# Access Compliance Report Public Rights-of-Way (Curb Ramps)

Main Street: ARROYO\_AVE Cross Street: SKYLINE\_DR Location: E

ADA ID: RPRK211011104956 Ramp Type: Type 1 - Perpendicular Diagonal Initial Pass/Fail: Pass Overall Compliance: No Severity Score: 15

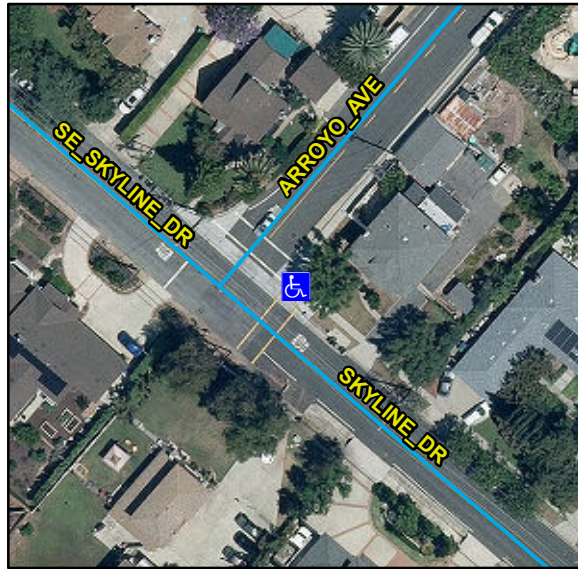
R304.2.2, R304.2.1, R304.2.2-Perp, R304.3.2-Para, R304.5.3, R304.5.4, STD 1115

Remove & Replace Curb Ramp With Two New Directional Ramps or Equivalent. Remove & Replace Gutter.
